UZBEKISTAN GAS TO LIQUID PROJECT (UZGTL)

HAZOP ACTION CLOSE-OUT REGISTER FOR MAKE-UP H2 COMPRESSOR PACKAGE

UZGTL-HDC-HSE-RP-50-0-0004

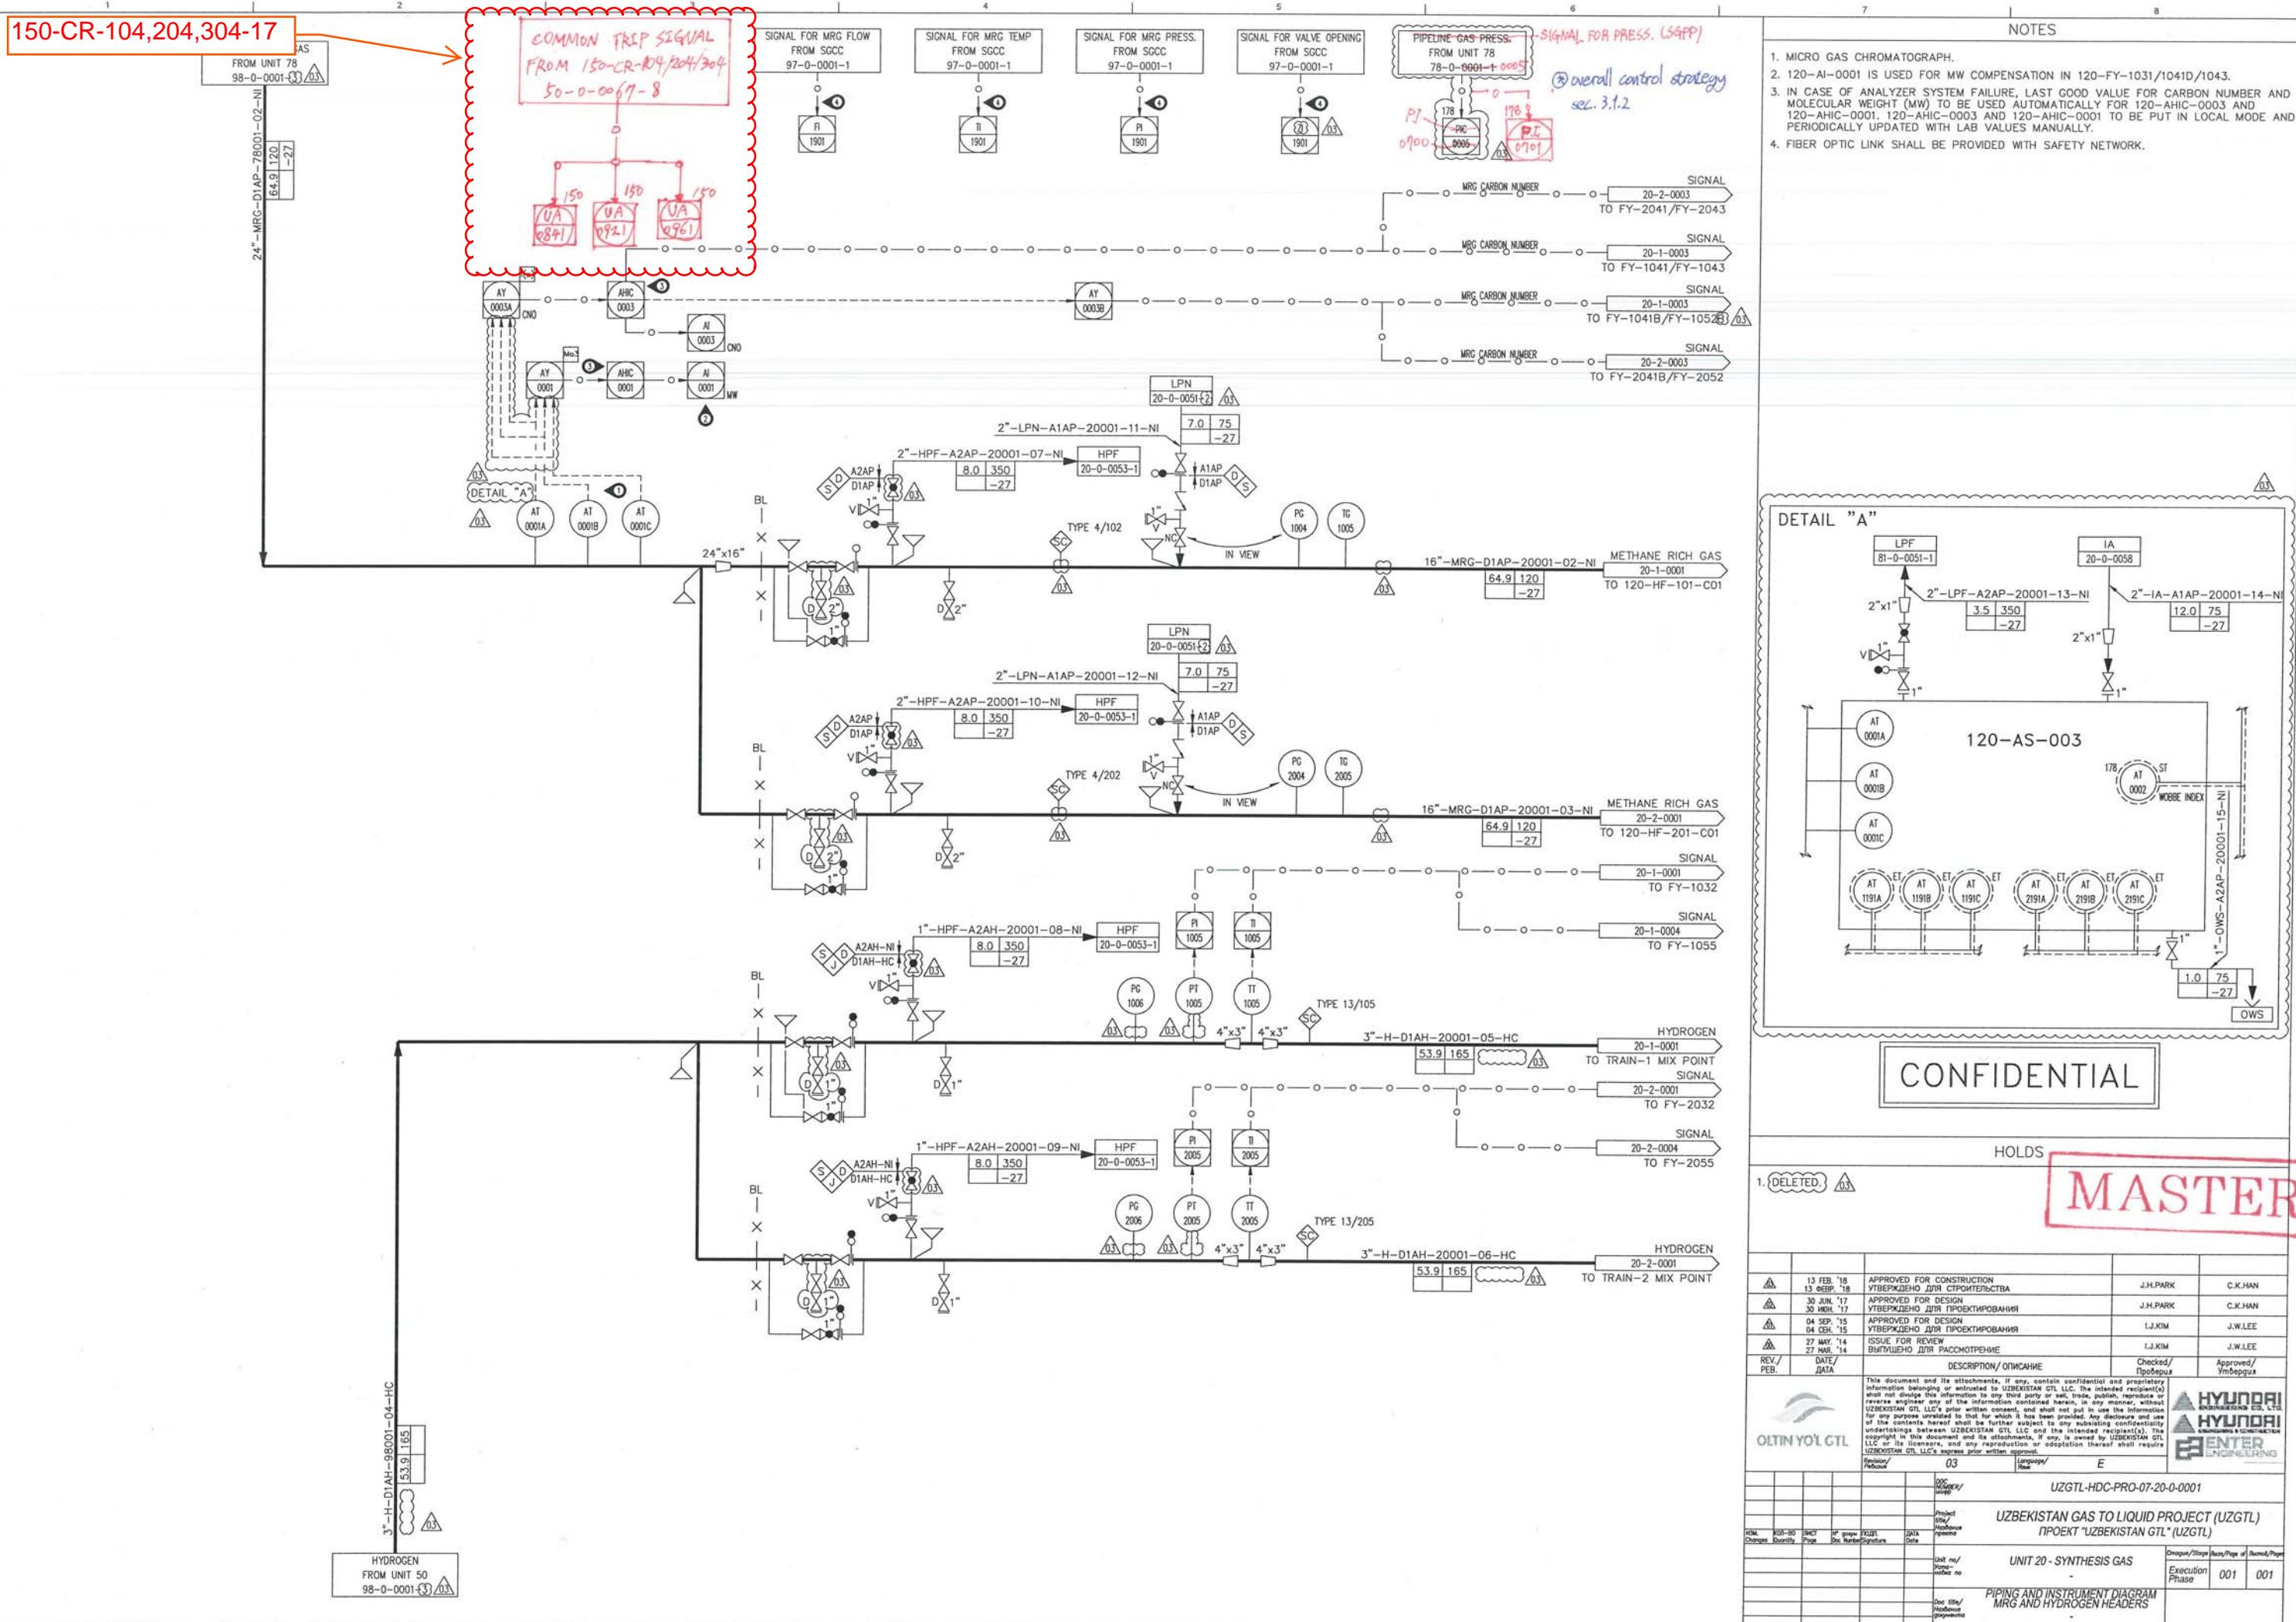
Action No.	150-CR-104/204/304-17	
Action By	PR	
Node No.	1	
Node Description	1. Compressor Process Gas / Compressor Vent & Drain / Compressor Unloader	
Cause	1.2.2. More Flow of process gas via 1st stage spillback line due to PIC control malfunction (1st stage spill back line malfunction open) (Refer to Unit 50 Process HAZOP)	
Consequence	1.2.2.1. 1st Stage suction pressure increase leading to potential compressor 1st stage discharge overpressure resulting in Compressor damage and gas leakage	
Safeguards	1.2.2.1.1. 150-PDAH-0835A 1.2.2.1.2. 150-PDSHH-0836A initiates 150-IS-0612 to trip Compressor 1.2.2.1.3. 150-TAH-0832A 1.2.2.1.4. 150-TSHH-0833A initiates 150-IS-0612 to trip Compressor 1.2.2.1.5. Compressor, 1st Stage Discharge Volume Bottle 150-CR-104-VD-72 and piping design condition 1.2.2.1.6. PSV on 1st stage discharge (set at 53.1 barg) (Process side)	
Action	Address compressor 150-CR-104/204/304 trip signal to Unit 20 and Unit 60

Response	Incorporated on P&ID (50-0-0065/66/67-8, 20-0-0001, 60-0-0004). Compressor 150-CR-104/204/304 trip signal will be provided to Unit 20 and Unit 60. (Please refer to attached P&ID, UZGTL-HDC-PRO-07-50-0-0065/66/67-8, 20-0-0001, 60-0-0004)
